Record of Decision Amendment

Operable Unit 2 (Deposit DD), Operable Unit 3, Operable Unit 4,
and Operable Unit 5 (River Mouth)

Lower Fox River and Green Bay Superfund Site

June 2007

Figure 1: Water Temperatures of the Namekagon River (USGS 2006)

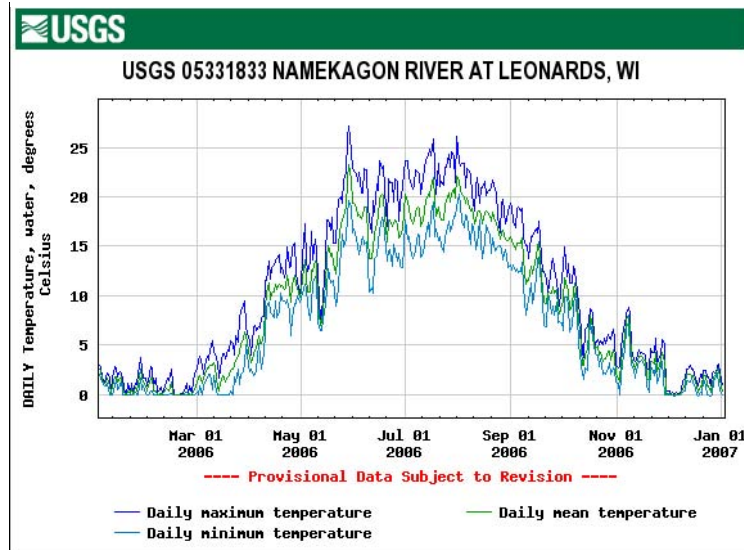
the Fox River and have concluded that the areas likely to have frazil ice are those just below the De Pere Dam (discussed in the paragraph above). Again, these areas will not be capped.

A review of the historical data shows that the analysis performed by Ashton on ice formation (2005) is cursory and incomplete. None of the conclusions are statistically verified, and fail to account for more extreme freezing events. The coldest temperature considered in the analysis is -5° F, while record lows of -20° and below have been recorded a number of times during the winter months. The analysis also does not investigate the effect of ice jams on additional ice formation in the areas behind the dam. It is unclear if such jams could result in ice impacting areas with caps.

The danger of ice scouring or attaching to caps is illustrated clearly in Ashton’s white paper by the passage “Occasionally anchor ice has been known to entrain the sediment to which it is attached into the flow when the ice releases from the bottom. The writer has seen small-fist-sized rocks in floating ice covers that undoubtedly were the result of such a process but when seen, these have been widely dispersed and represent only insignificant transport.” What Ashton doesn’t note is that cap integrity is unrelated to the amount of sediment transported in this fashion. Fist sized holes in caps compromise both their ability to contain sediments and also the ability to resist future scouring events.

The Agency agrees with the technical concerns for the impact of ice jams and/or frazil ice on locations chosen for capping in the Amended Remedy (ice jam potential discussed above). In Attachment D to Appendix D of the BODR in a report entitled, "Effects of Ice on Sediments in Fox River Near Green Bay, Wisconsin," by George D. Ashton, Ph.D., July 10, 2005, it was concluded frazil or anchor ice formation could form in the 1 ½ miles of river in OU3 below the Kaukauna Dam, and the first 1400 feet of river below the De

Pere Dam in OU4. Therefore, no capping will be done in those areas. Dr. Ashton concluded that there were no areas in OU3, OU4, or OU5 that are likely to experience ice jams, as discussed in the preceding comment response. Dr. Ashton based his observations both on the United States Army Corps of Engineers database, and local reports.

Figure 2: Flash Flood Data for Green Bay, WI (National Weather Service, 2006)

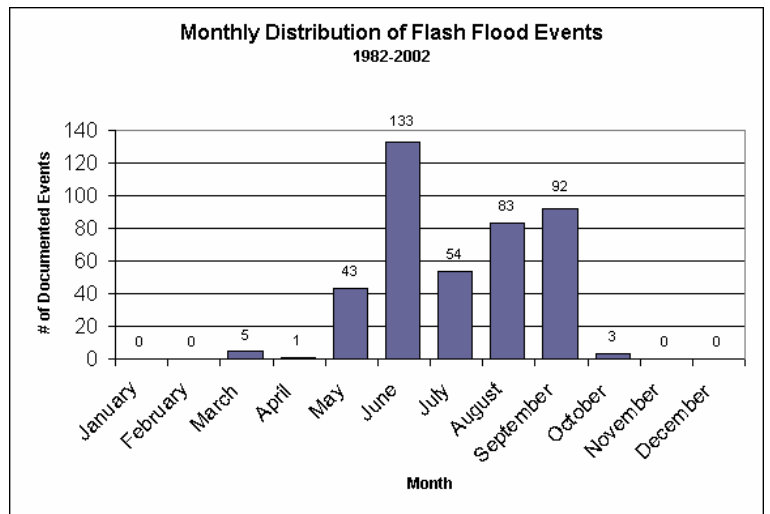
Flooding is also a significant threat to caps in the Fox River. As shown in Figure 2, significant precipitation events and therefore discharges in the Fox River over the past 20 years occur mainly from May to September, with the greatest number of previous flash flood events recorded in June (NWS). The largest recorded discharge (33,800 cfs) recorded at the mouth of the river also occurred in June over sixteen years ago. Data were obtained from the USGS water database, which is available on the internet at <http://waterdata.usgs.gov/nwis/sw>. Attempting to determine average discharges at the mouth of the river from USGS data is difficult as the agency appears to only take data from this station sporadically.

Data have been collected more regularly from a station in Wrightstown which has recorded 2 events approaching the 100 year flood estimate of 24,200 cfs used in the BODR (USGS). The station is located at the Rapid Croche Dam, which according to the USGS may influence discharges because of flow restrictions and other dam related activities. However, according to Figure 1-1 of the BODR this location is approximately 22 miles from the mouth of the river (Shaw, 2006). The two events in 1952 and 1960 had discharge rates of 24,000 and 23,600 cfs respectively. Locations downriver have experienced even greater discharges. One instance in 1990 caused a discharge of 33,800 cfs, and the same event caused a flow rate of over 46,000 cfs at the mouth of the East River as it flows into the Fox River (Baumgart, 2007, see attached figure). These high flow rates were caused by a combination of heavy rains and a powerful seiche. A seiche occurs when strong northwesterly winds build up water in the bay, which alters water levels and flow rates. The above data indicate that flood events of the calculated 100 year flood magnitude occur much more frequently than estimated, and wind can play a role in these events.

Figure 3: Frequency of Storm Related Wind Events in Green Bay, WI. (National Weather Service, 2006)

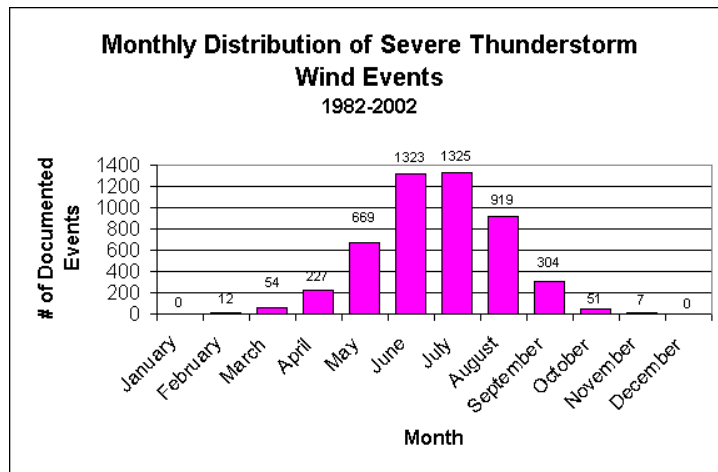
Other weather related events could have an indirect impact on caps within the Fox River. High wind events on waterways can lead to accidents or unplanned occurrences such as ships breaking their moorings and running aground in shallow areas. Institutional controls are of no use in these situations, so they must be planned for accordingly. Severe weather wind events occur primarily in the summer months, with a similar temporal distribution as flood events (Figure 3). While wind events are unlikely to have the same impact as flooding or ice formation/jams, they should still be considered when evaluating suitability of a site for a cap.

The above data indicate that caps in the Fox River have a high risk of being compromised by scour events 10 months out of the year. The potential for ice related scours is high though the winter months, and through the summer and early fall flood events become a significant concern. Placing a cap in such a high risk area is completely unacceptable.

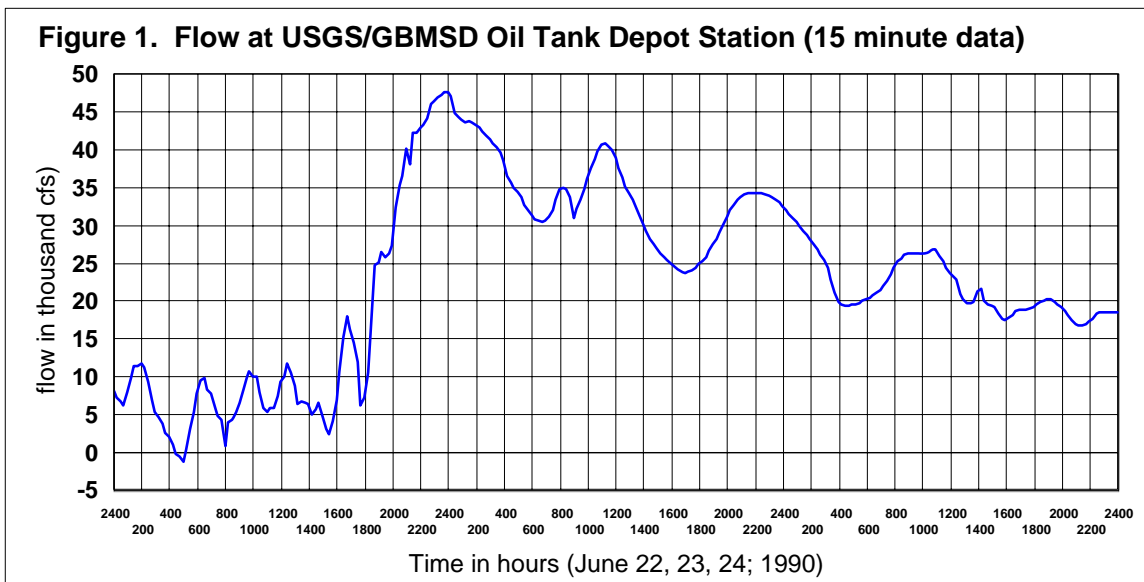
We strongly recommend against this change. The increased risk of leaving “hot spots” in the river, in our opinion, far outweighs the marginal cost savings. Throughout the earlier planning efforts, it was acknowledged that riverine sediments with higher PCB concentrations posed the greatest risk to long term contamination of the Bay. At the same time, it was shown that dredging high concentration areas provided a cost effective means of removing PCB mass from the ecosystem. Therefore, we see no reason to modify the original ROD guidance on this issue.

The only locations where PCBs above 50 ppm would be capped are areas in the navigation channel where contaminants are deeply buried and in near-shore areas where shoreline stability would be in question. In these locations there would be some dredging and then capping with thicker sand, and larger armor stone (preliminary designs call for 15-inches of sand and 18-inches of large stone). Thus, the cap over these deeply buried, higher level PCB sediments would be especially stable and robust. It is highly unlikely that these deeply buried sediments would be subject to erosion or re-exposure, particularly because these areas would have a thicker cap with larger armor stone. In areas where the PCBs are nearer the surface, with higher PCB concentrations, or in areas more subject to erosion or disruption, dredging would be done.
